RE: Badger Minerals Schoepke Project – Notice of Intent to Drill – Disturbance Estimate for Stormwater – Erosion Control

Badger Minerals – Schoepke Project – Soil Disturbance Estimate – Additional Details

Figure 1. Revised Plan Map for Schoepke Drilling Project

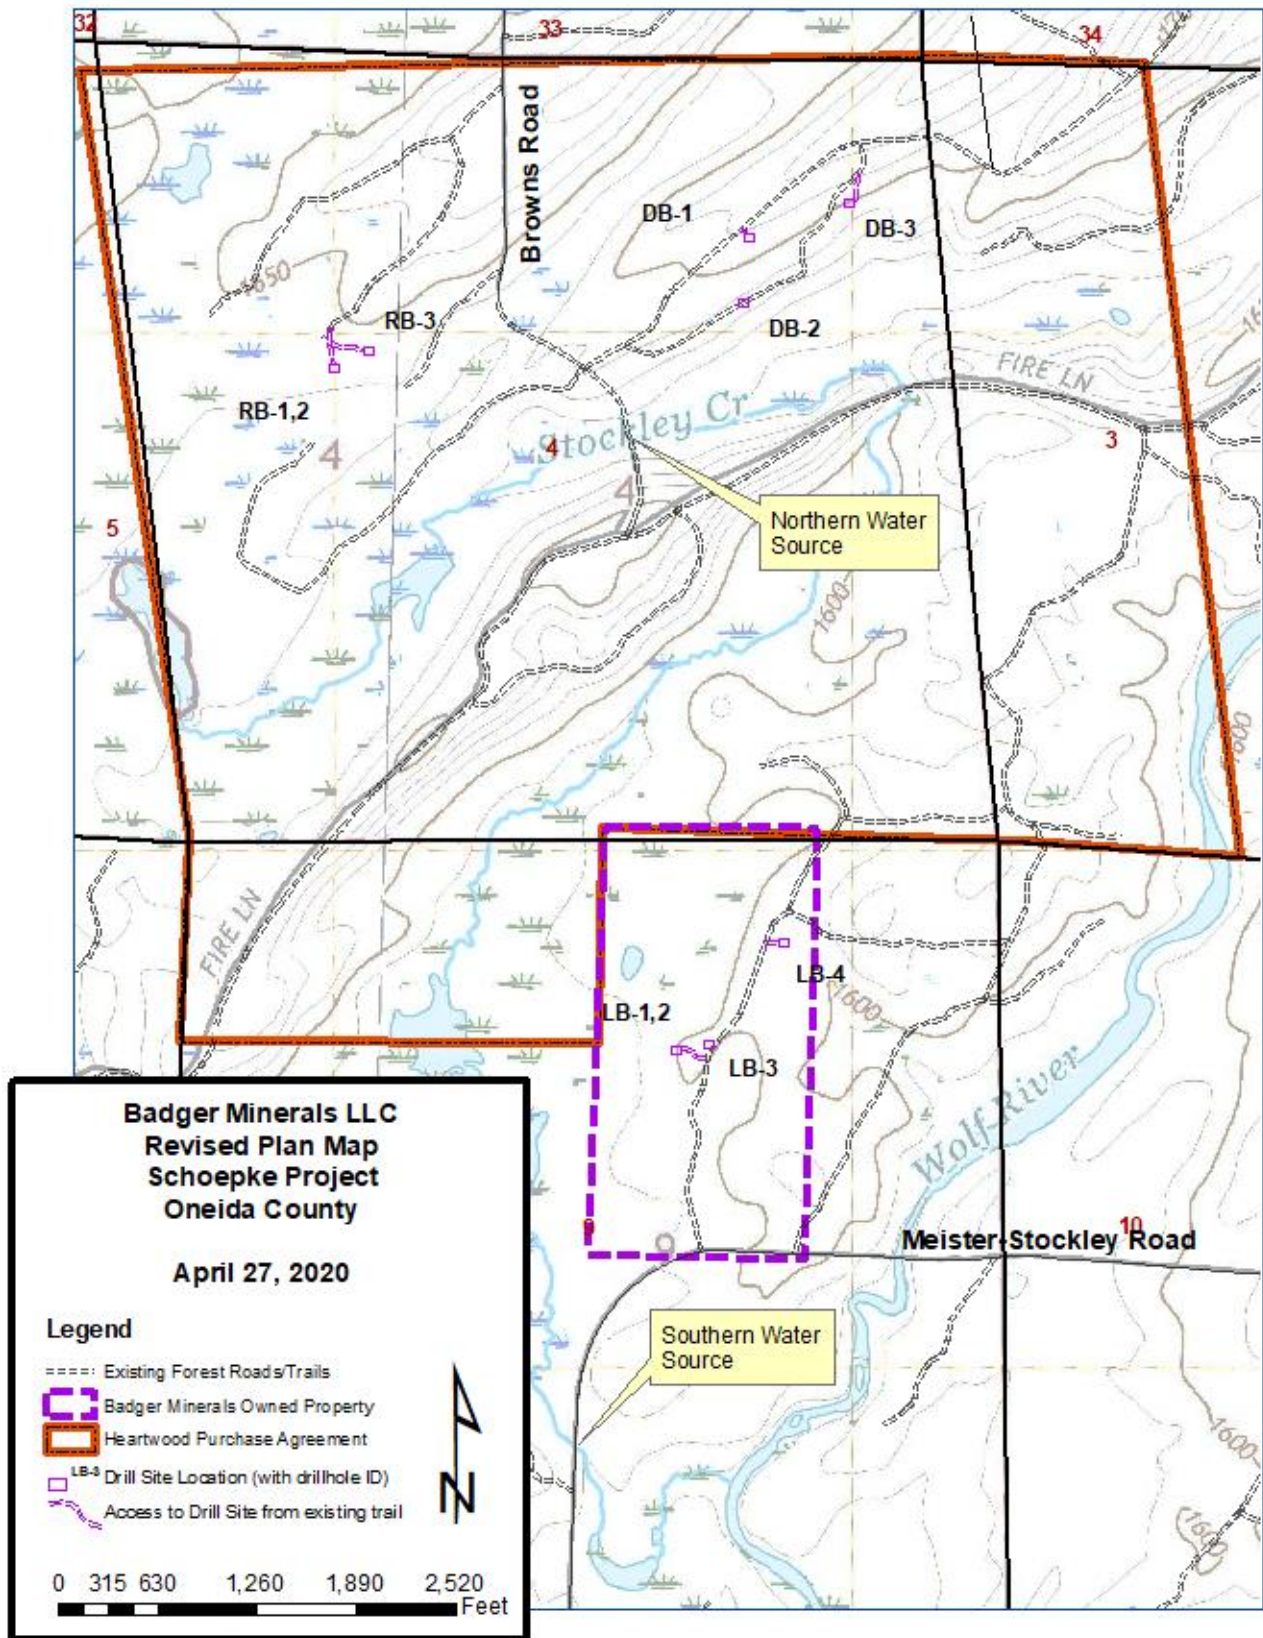
The following information is provided in response to the Departments comments to Badger Minerals' Notice of Intent to Drill document which were received by Badger Minerals on February 7, 2020. Included within the document, with respect to the section "Stormwater – Erosion Control", you had requested additional information outlining the planned disturbances related to the exploration drilling at the project and had advised that if the "total land disturbance was equal to or greater than one acre, a construction site permit is required under NR 216, Wis. Adm. Code".

1. Badger Minerals has revised their proposed drill plan to exclude the drill sites RB-02 and LB-02 (see originally submitted NOI document) decreasing the total number of proposed drill site to 8 (10 previously). The total number of drill holes and estimated footage has not changed and it is planned that the holes originally planned to be completed at the excluded sites can be drilled from the adjacent drill sites (RB-01 and LB-01). See **Figure 1** below for revised drill site locations.

3. **Figure 1** below shows the locations of the proposed drill sites relative to the location of existing forest roads/trails. While some of the proposed drill sites are located immediately adjacent to these roads (LB-3, DB-2), other sites will require a path to be cleared for access. Disturbance calculations incorporated the length of the access from existing roads and assumed a 10' width of the path. Calculations are tabulated in **Table 1** above. Total surface area of all access paths is estimated to be 9,500 square feet.

Access to water withdrawal locations (**Figure 1**) will take place along the side/shoulder of existing roads and are not anticipated to cause disturbances. As a precaution, silt sock or silt fence will be placed in-between the shoulder of the road and the water source to prevent unanticipated sedimentation to the water body.
